HISTORIC AND DESIGN REVIEW COMMISSION

HDRC CASE NO: 2024-163
ADDRESS: 271 W WILDWOOD
LEGAL DESCRIPTION: NCB 9013 BLK 7 LOT 82 83 AND 84
ZONING: R-4, H
CITY COUNCIL DIST.: 1
DISTRICT: Olmos Park Terrace Historic District
APPLICANT: Julia Castillo/CASTILLO JULIA A
OWNER: Julia Castillo/CASTILLO JULIA A
TYPE OF WORK: Fenestration modification to the existing garage structure
APPLICATION RECEIVED: April 10, 2024
60-DAY REVIEW: June 10, 2024
CASE MANAGER: Claudia Espinosa

REQUEST:

The applicant is requesting a Certificate of Appropriateness for approval to infill the existing front-facing garage door opening with horizontal composite lap siding and a set of ganged one-over-one vinyl window.

GARAGE DOOR
REPLACEMENT
WITH WINDOW

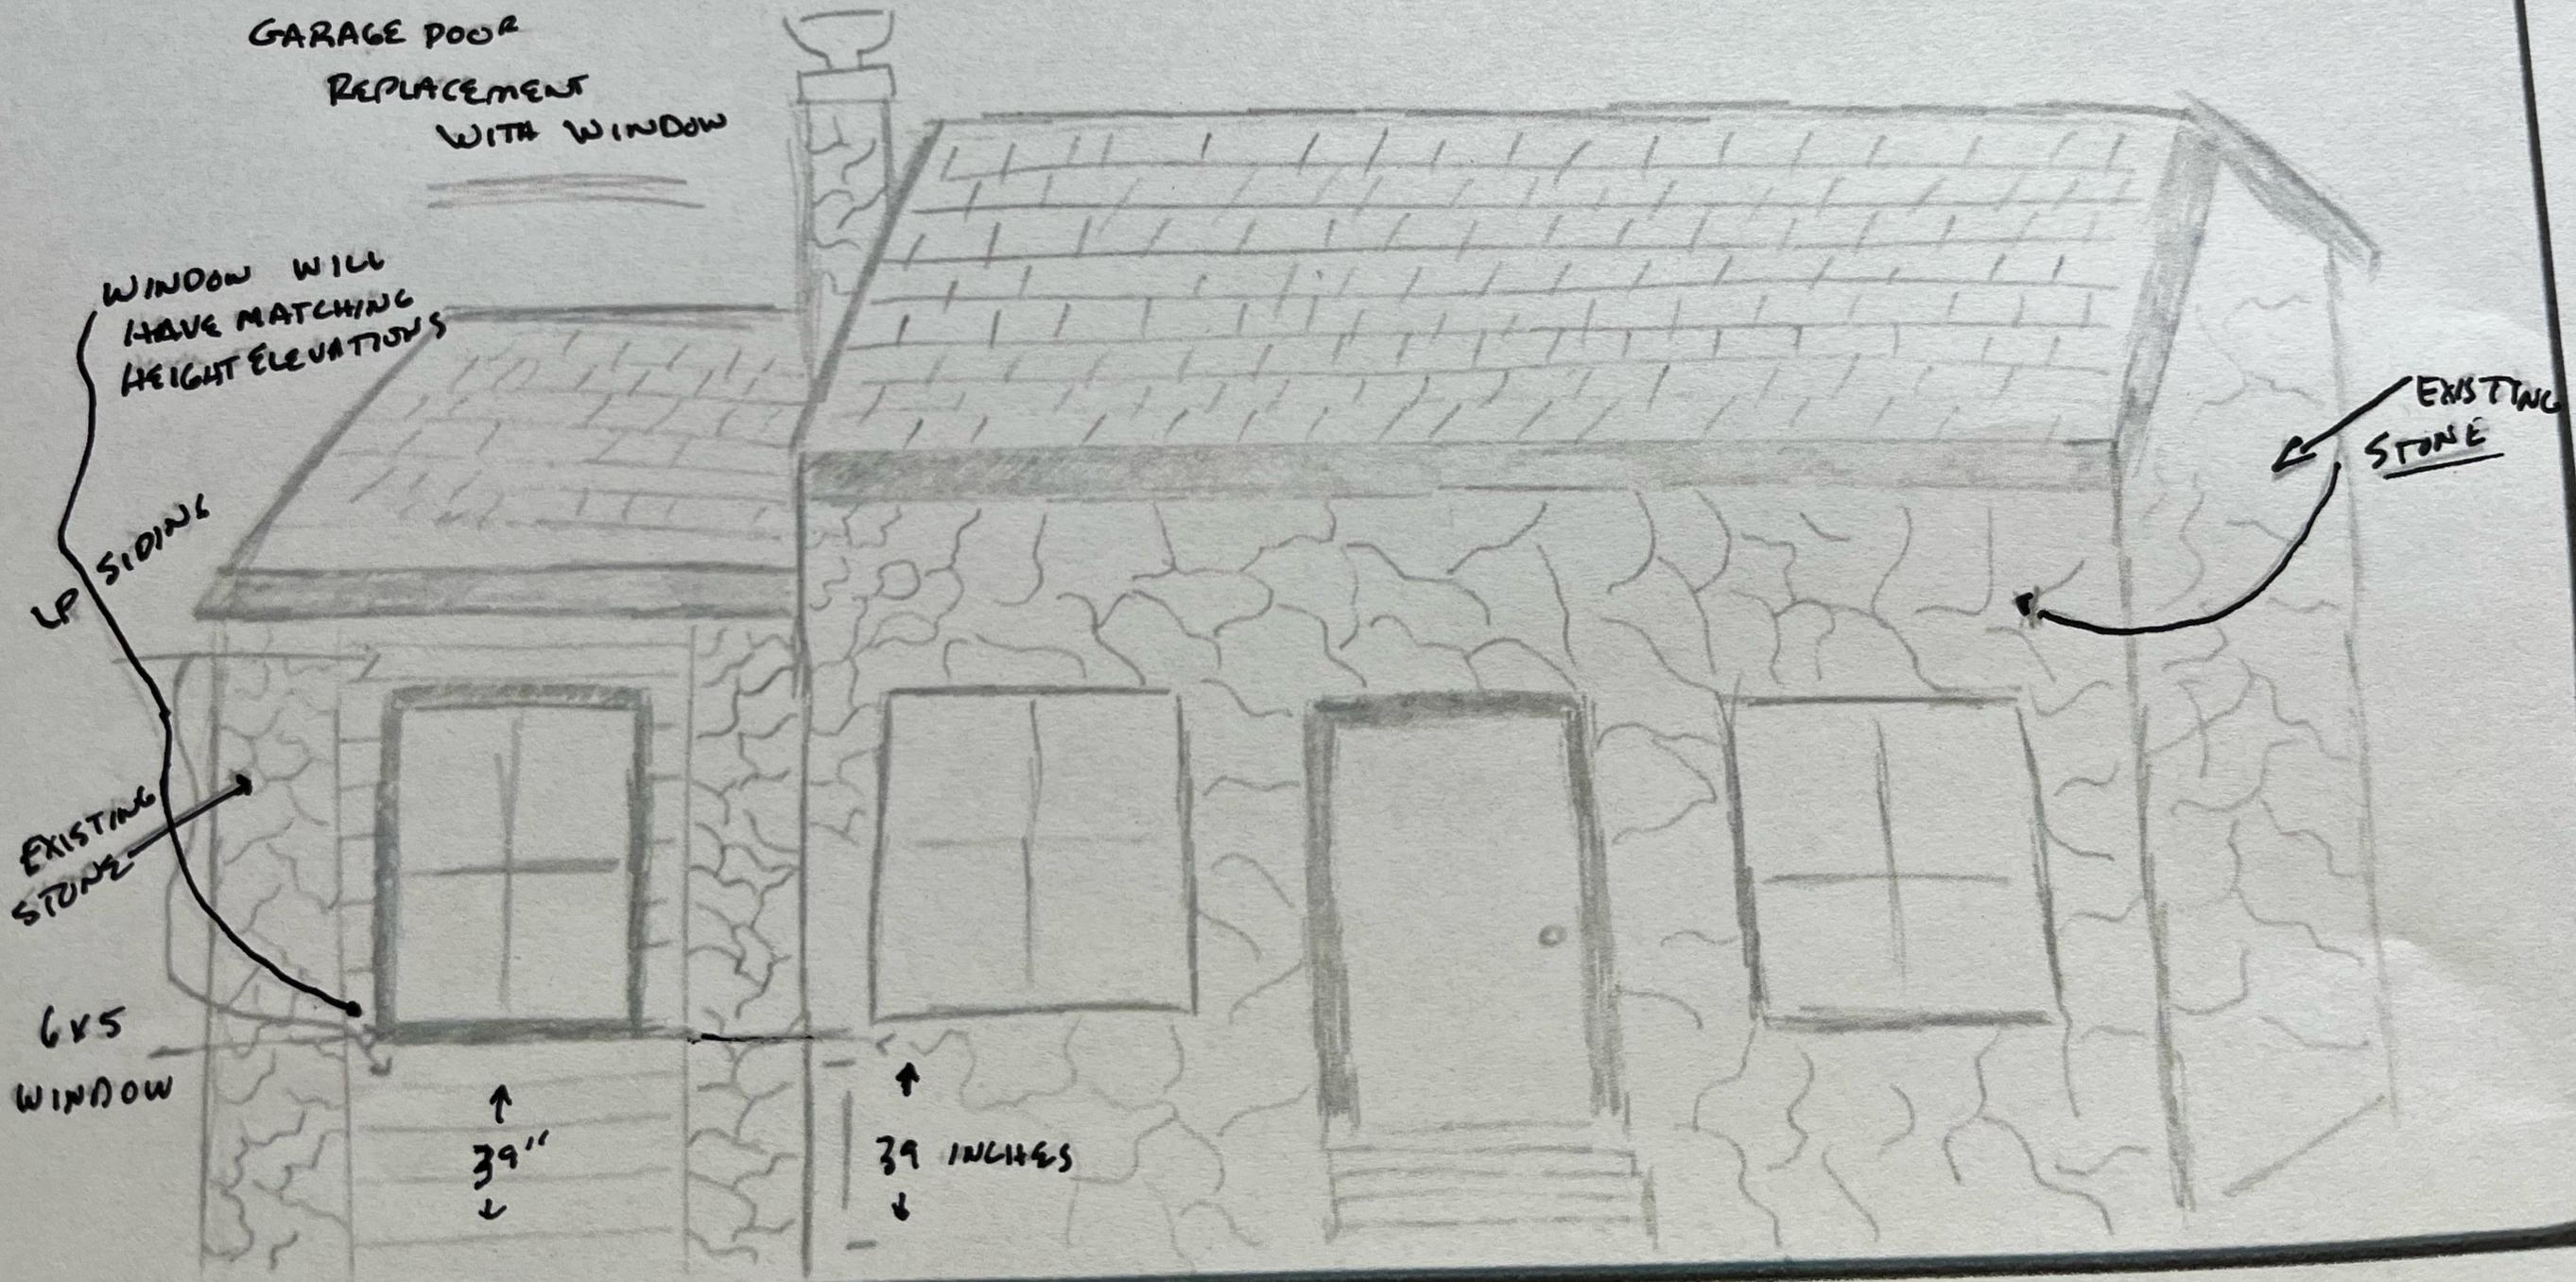
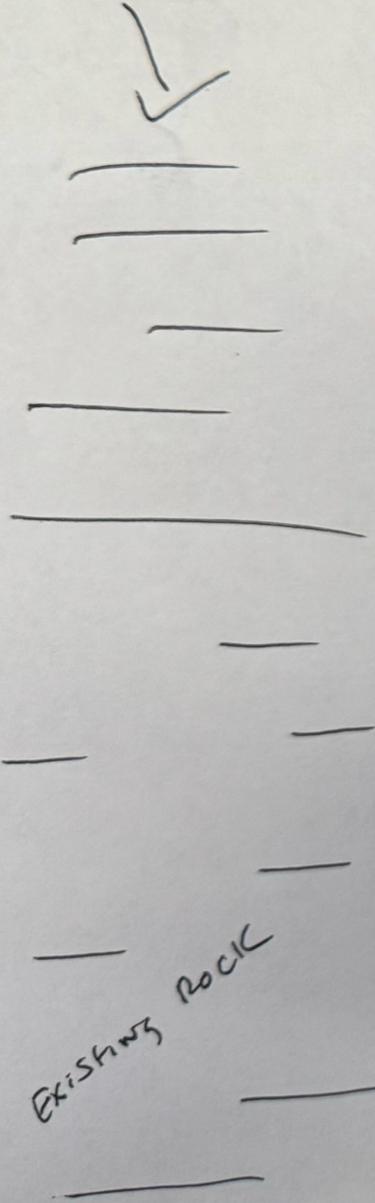
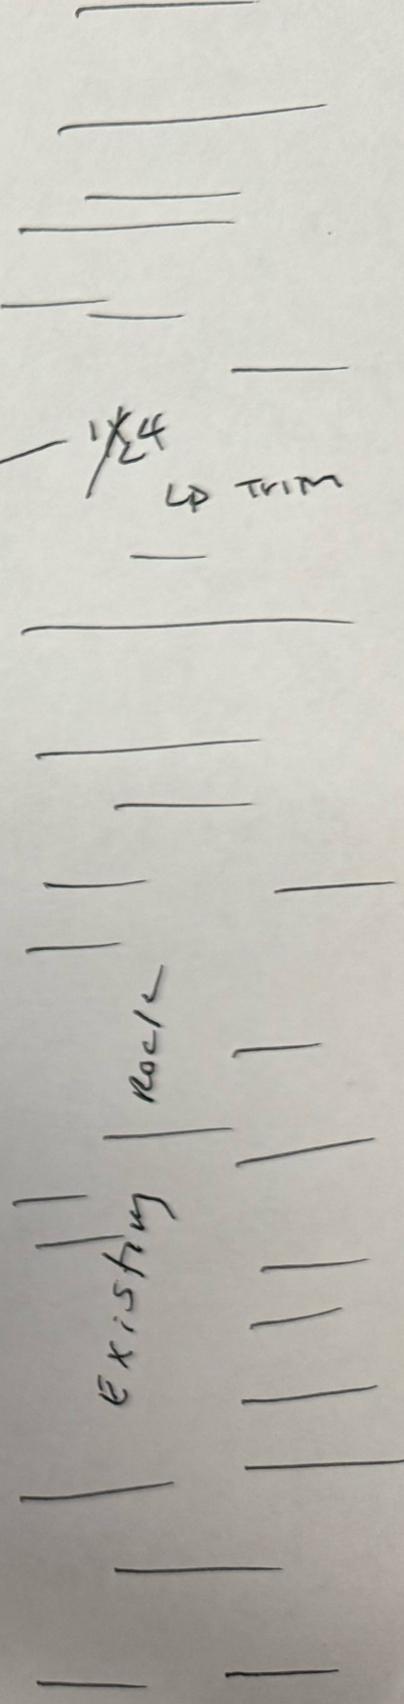
- b. GARAGE DOOR (INFILL) – The accessory structure currently features a single bay with a metal garage door. While the door itself has been replaced over time, this configuration is original. The applicant has proposed to remove the door and enclose the area with horizontal lap siding and add two, ganged vinyl windows. The Historic Design Guidelines for Exterior Maintenance and Alterations state that the original window and door opening should be preserved. Any infill at this location should result in a condition that is visually similar and reads as a garage door.

- c. INFILL (MATERIALS) – The applicant requests approval to remove the existing metal garage door and infill the opening with horizontal Hardie lap siding and a set of ganged one-over-one vinyl windows. The Guidelines for Additions 3.A.i, state to use materials that match in type, color, and texture and include an offset or reveal to distinguish the addition from the historic structure whenever possible. Any new materials introduced to the site as a result of an addition must be compatible with the architectural style and materials of the original structure. The proposed siding is not a compatible material with this structure and results in an appearance that is dissimilar from the original garage door configuration.

- d. WINDOW INSTALLATION– At this time the applicant is requesting to install a set of ganged one-over-one vinyl windows on the front façade of the addition. Per the Standard Specifications for Windows in Additions or New Construction, new windows on additions should relate to the windows of the primary historic structure in terms of materiality and overall appearance. Windows used in new construction should be similar in appearance to those commonly found within the district in terms of size, profile, and configuration. While no material is expressly prohibited by the Historic Design Guidelines, a high-quality wood or aluminum-clad wood window product often meets the Guidelines with the stipulations listed below. Whole window systems should match the size of historic windows on the property unless otherwise approved.

- i. That alternative cladding materials be proposed, namely a paneling that mimic the appearance of a garage door based on finding b and c.
- ii. That the applicant revise the proposed fenestration pattern to propose window opening that conform with windows that might normally be found on a garage door based on finding d.
- iii. That window materials be consistent with staff's standards for new windows to additions based on finding d.
